Environmental Planning Commission

Agenda Number: 5
Project #: PR-2019-003120
Case #: RZ-2022-00039
SI-2022-01513
Hearing Date: September 15, 2022

Staff Report

Agent	Consensus Planning.
Applicant	Mack ABQ I, LLC
Request	Zoning Map Amendment (zone change) Site Plan - EPC
Legal Description	Tract A-1, Plat Of Tracts A-1 Thru A-6 Unser & Sage Marketplace, (being a replat of Tract A Unit 1-B Lands of Albuquerque South)
Location	Sage Rd. SW, between Unser Blvd. SW and Secret Valley Dr. SW
Size	Approximately 5.0 acres
Existing Zoning	MX-T
Proposed Zoning	PD

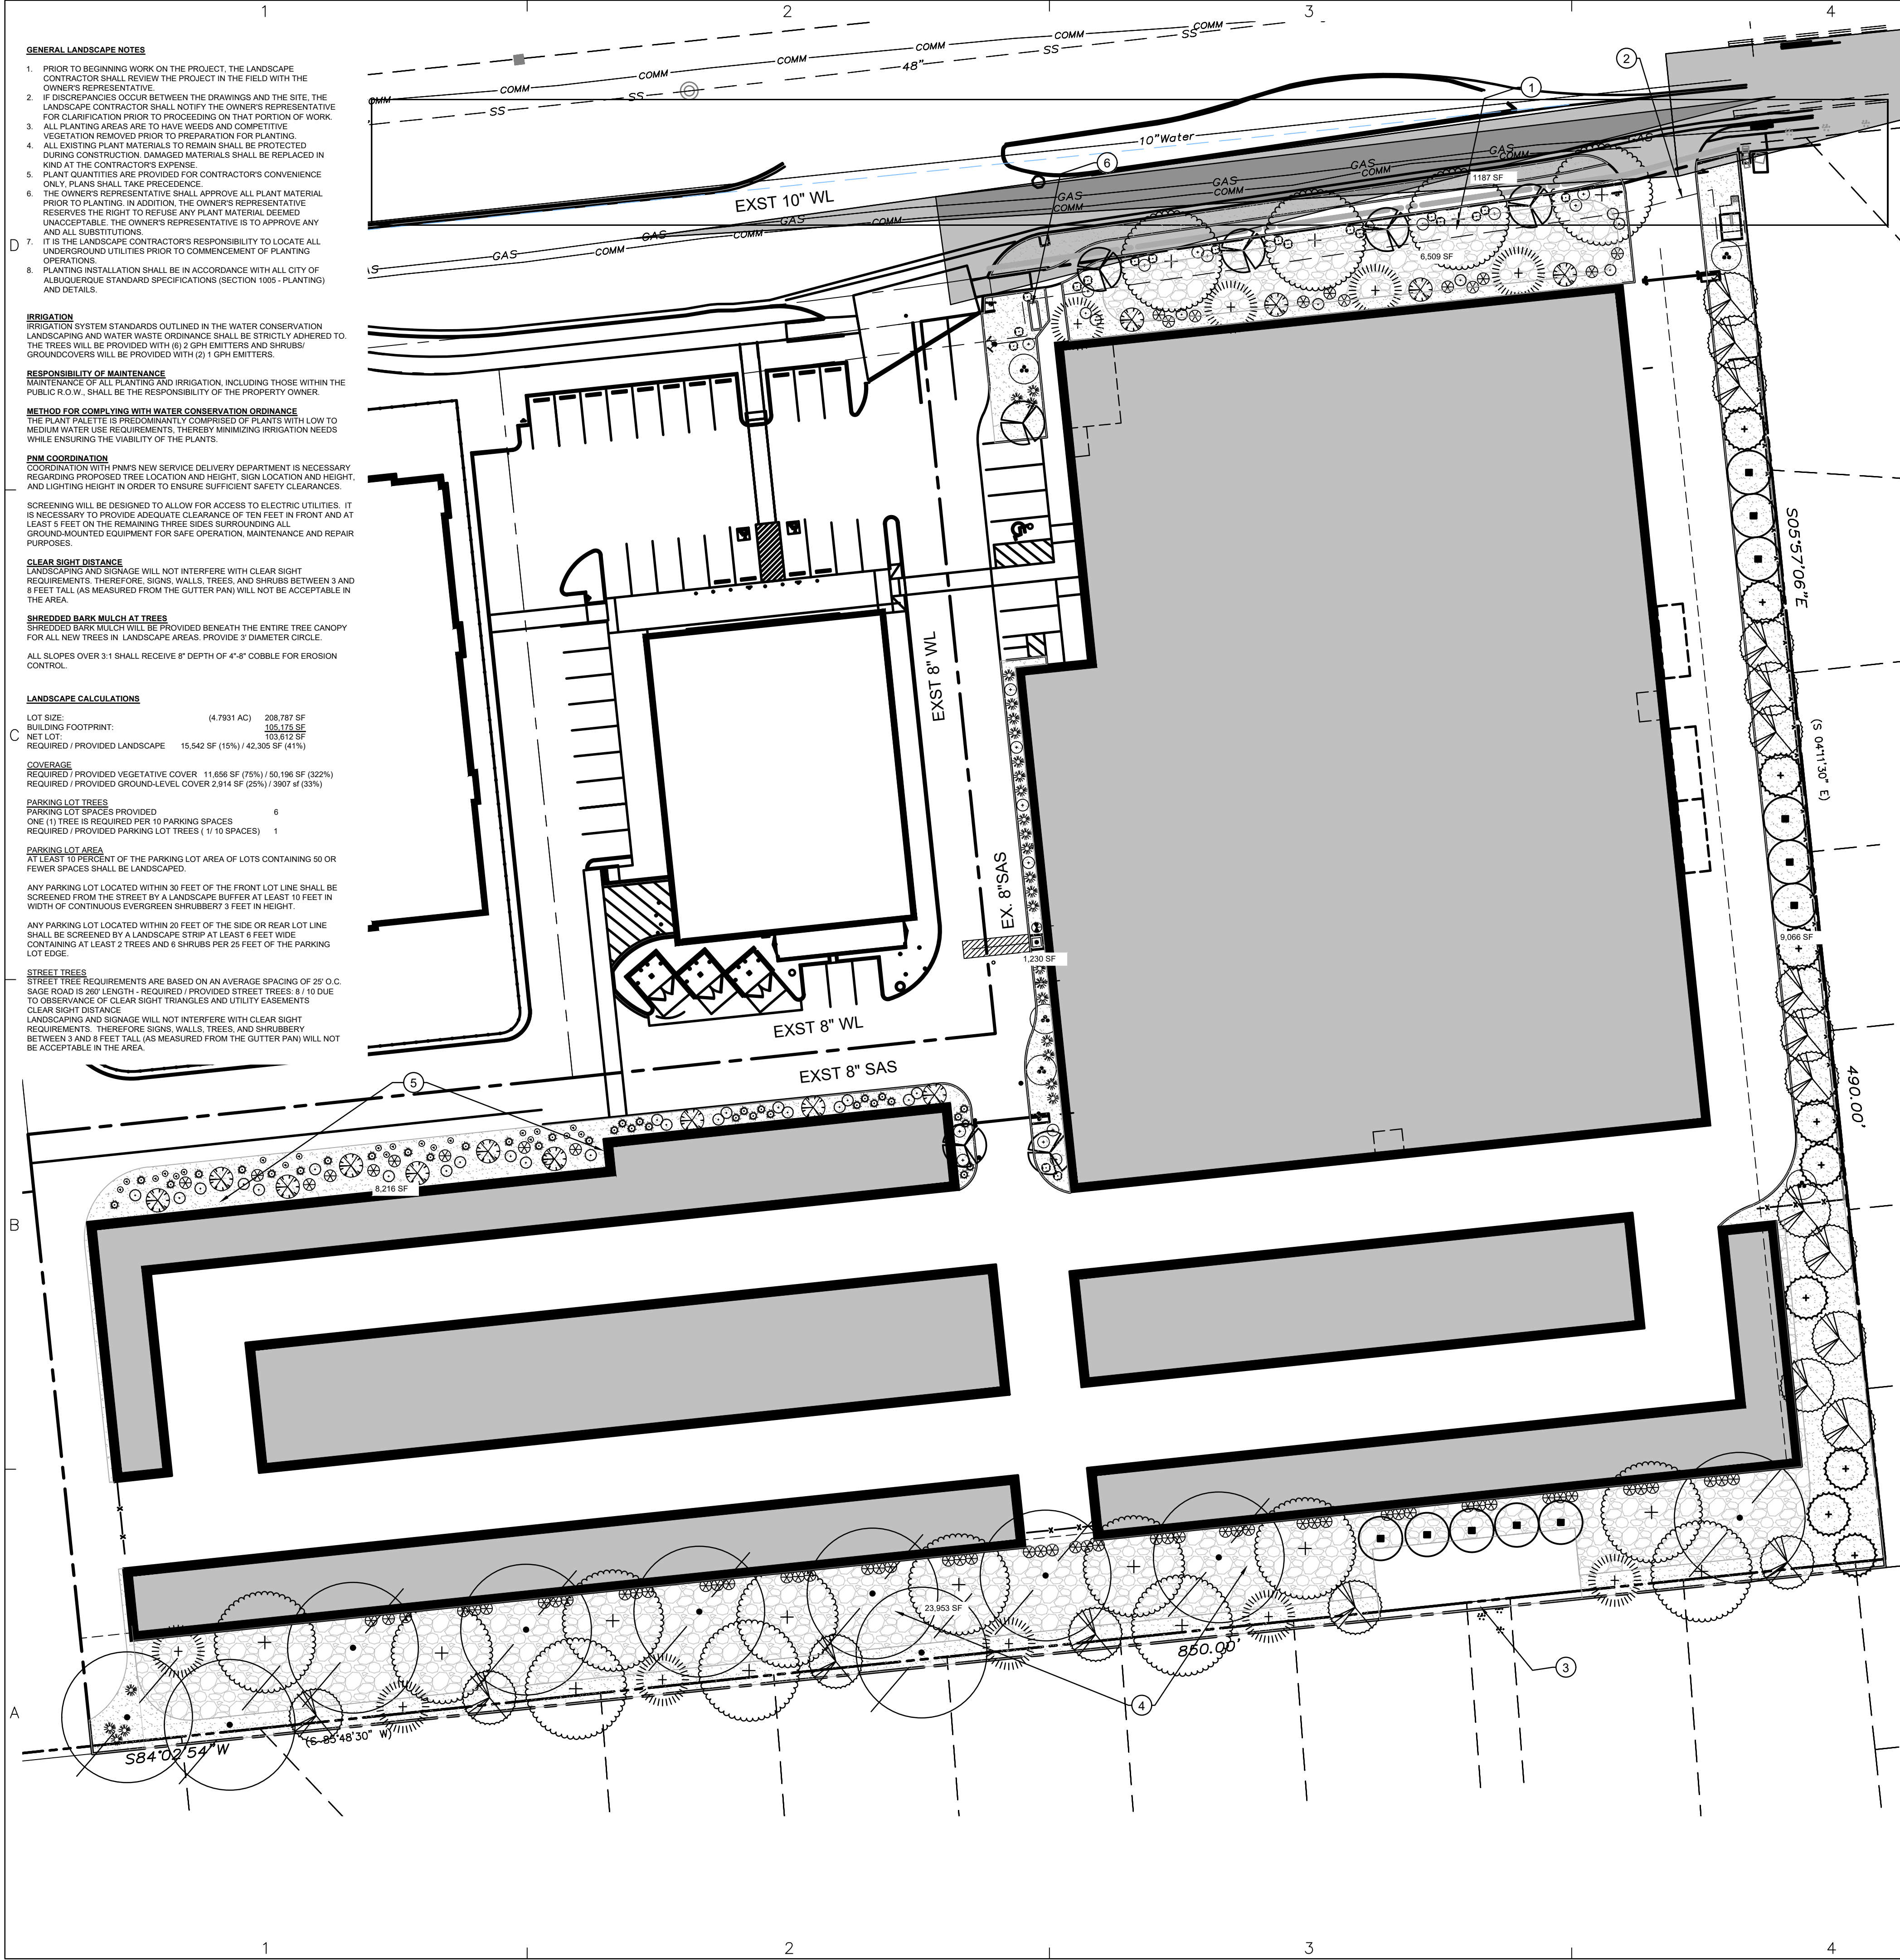
There are existing sidewalks along Unser Blvd SW, and some on Sage Rd SW, though new sidewalk is being proposed. The width of the proposed sidewalk is not called out on the site plan. Currently the site plan does not show on site pedestrian crosswalks that comply with 5-3(D)(3) (C), which requires that said crosswalks use change in materials to alert motorists.

5-5 Parking and Loading: Parking calculations are shown on the first sheet of the Site Plan. Per IDO Table 5-5-1, 1 space / 3,000 square feet are required. This would require 35 spaces of parking.

However, the applicant proposes only six parking spaces for the development. Parking for the light-vehicle rental use is not discussed in the project letter or the site plan.

The applicant is proposing 42,305 square feet of landscaping which equals to 41% lot coverage. This far exceeds the MX-L requirement of 15% lot coverage for landscaping. There are landscape buffers abutting the residential area, however, they are not dimensioned on the proposed site plan.

There is a fence proposed on the eastern portion of the subject site, however, materials and height are not called out on the site plan.

There is no lighting shown on the proposed site plan.

CONCEPT BUILDING ELEVATIONS

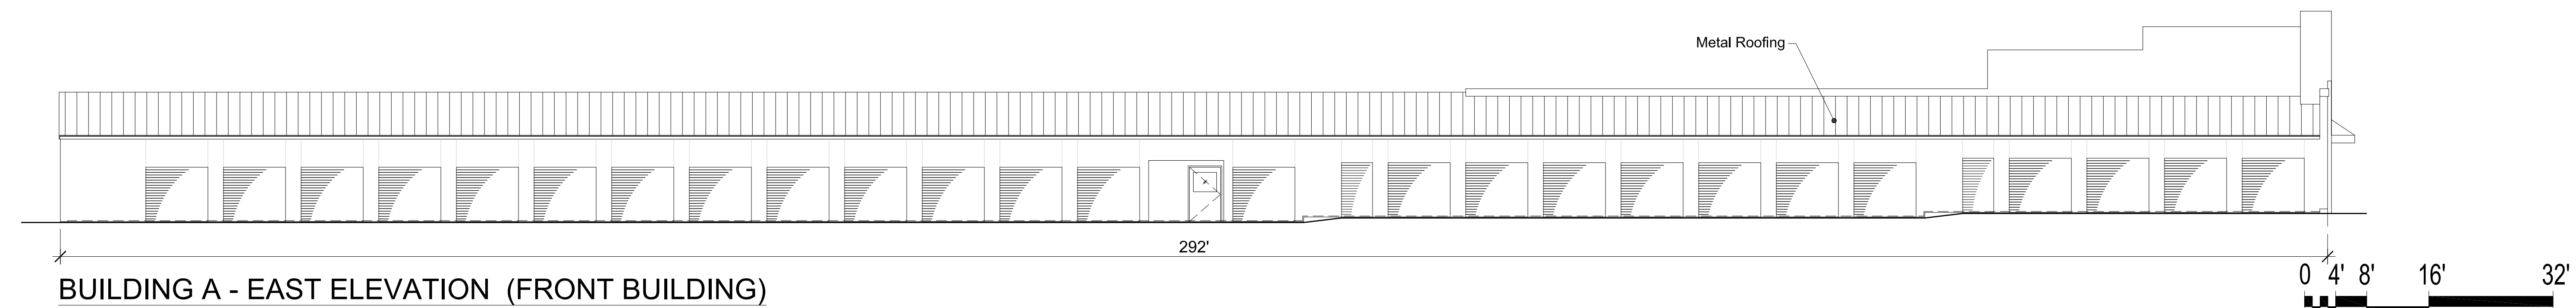
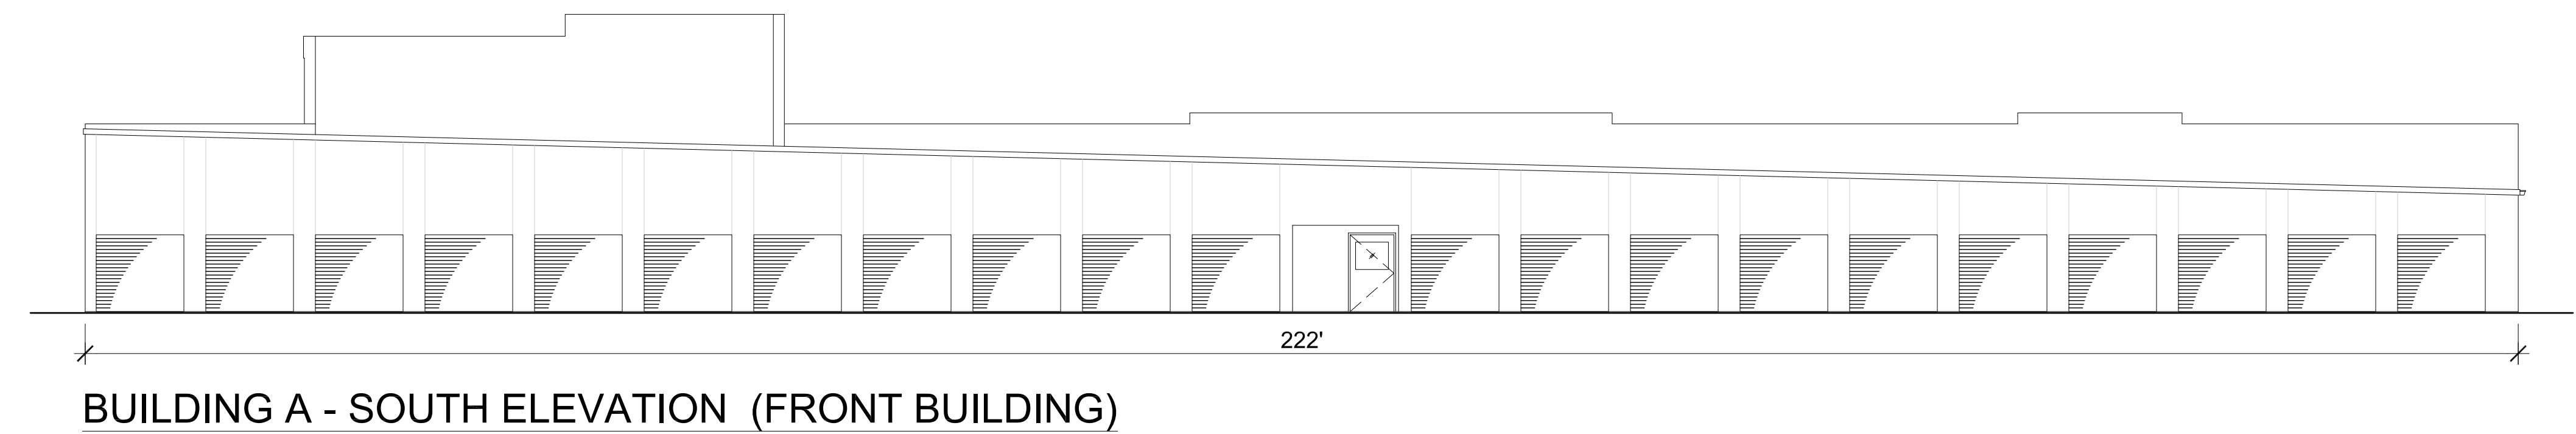
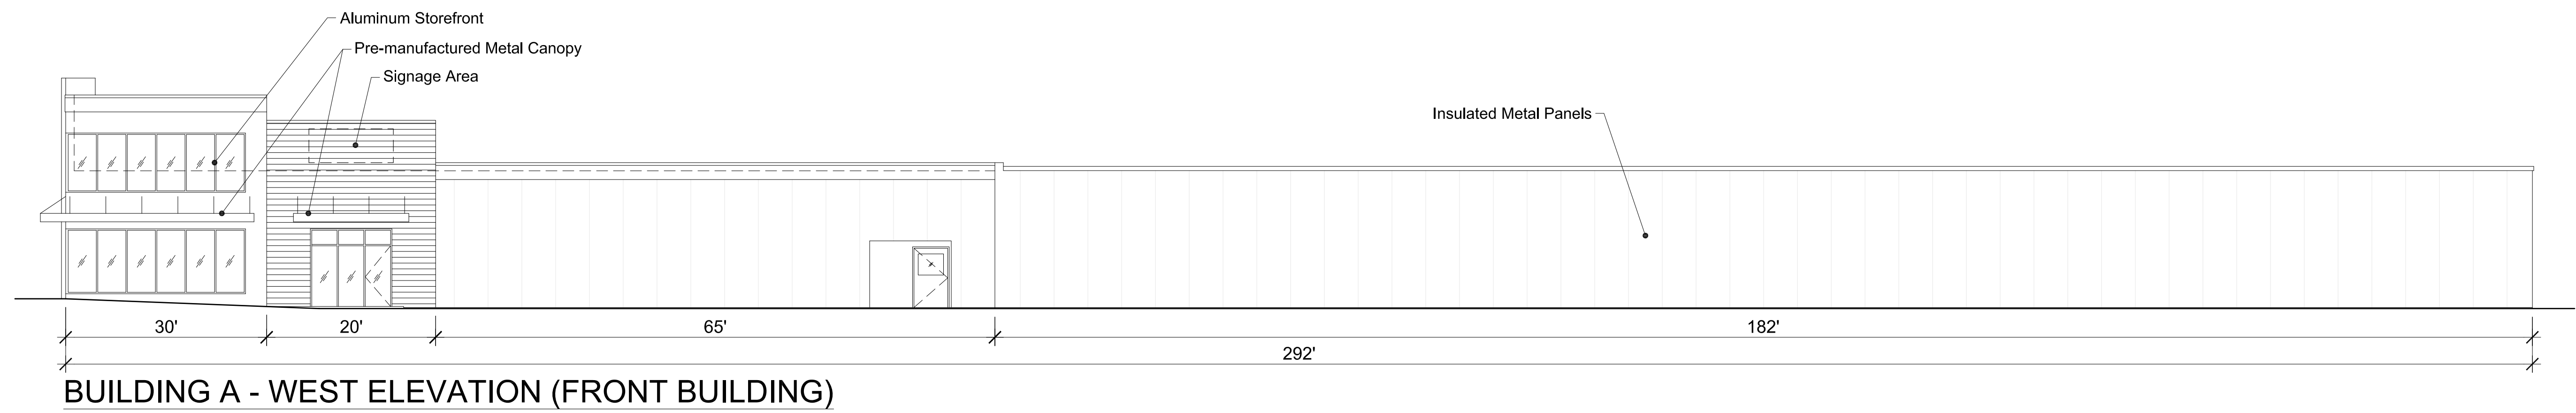
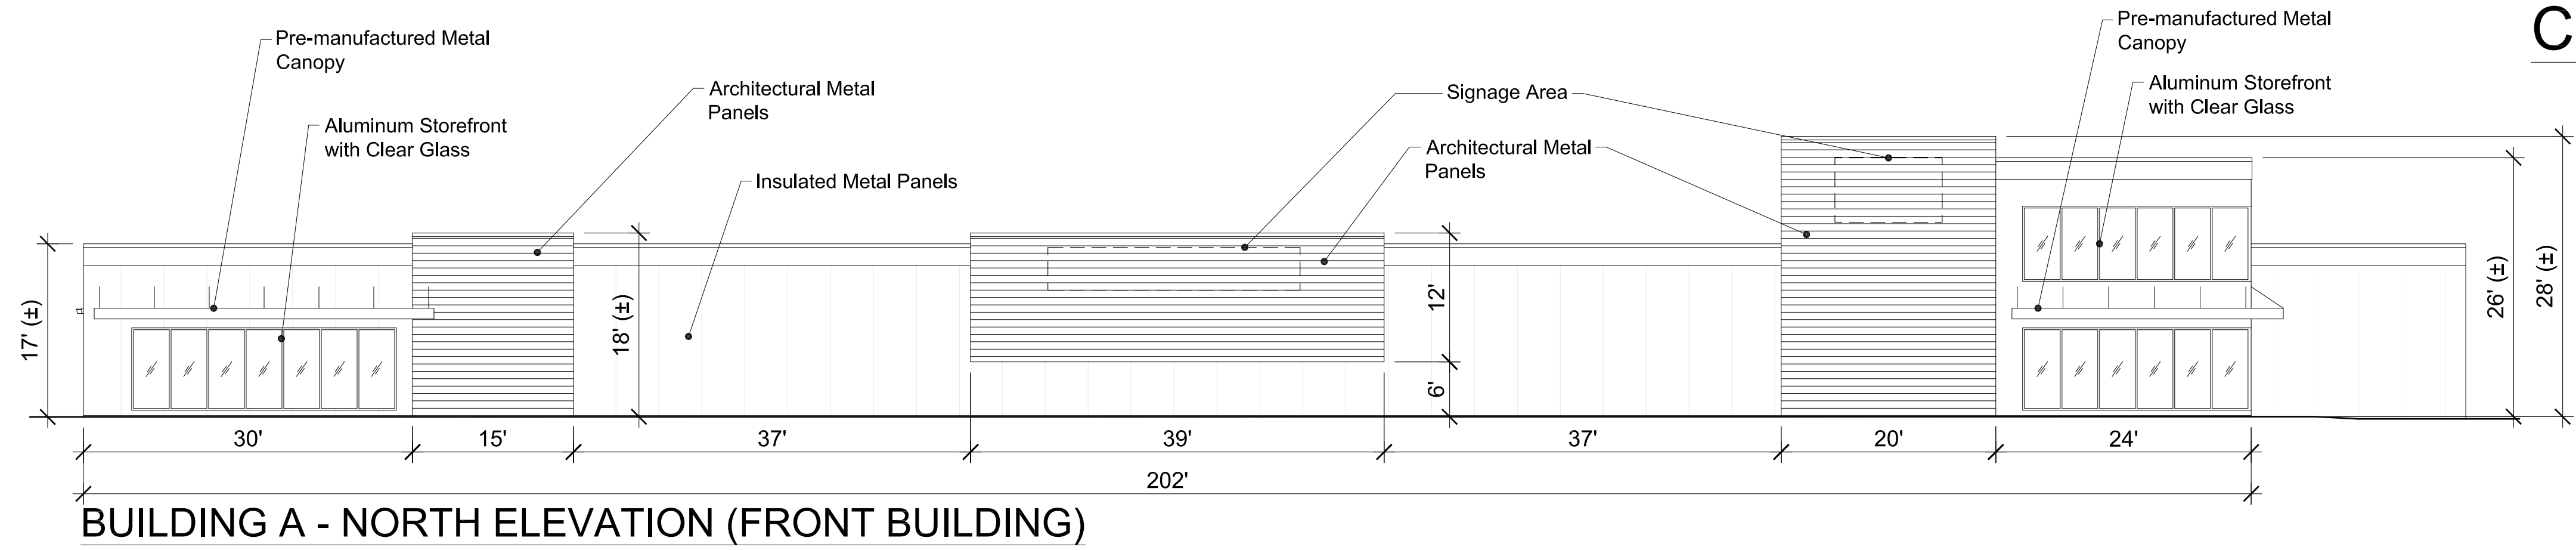
Building signage is shown on the elevation drawings, it is not dimensioned. There is no new site signage shown on the proposed site plan, but there appears to be an existing monument sign within the project boundary.

5-11: Building Design: The street facing façade has design features required in the MX-L zone district including two levels of glazing and changes in material. Materials are called out but colors of the materials are not shown or called out on the elevations. The outdoor accessible storage units are comprised of insulated metal paneling and roll up doors, again, no colors are shown or called out on the elevations. The elevations should clearly indicate which standards are being met, and which are being negotiated through the Site Plan – EPC process.
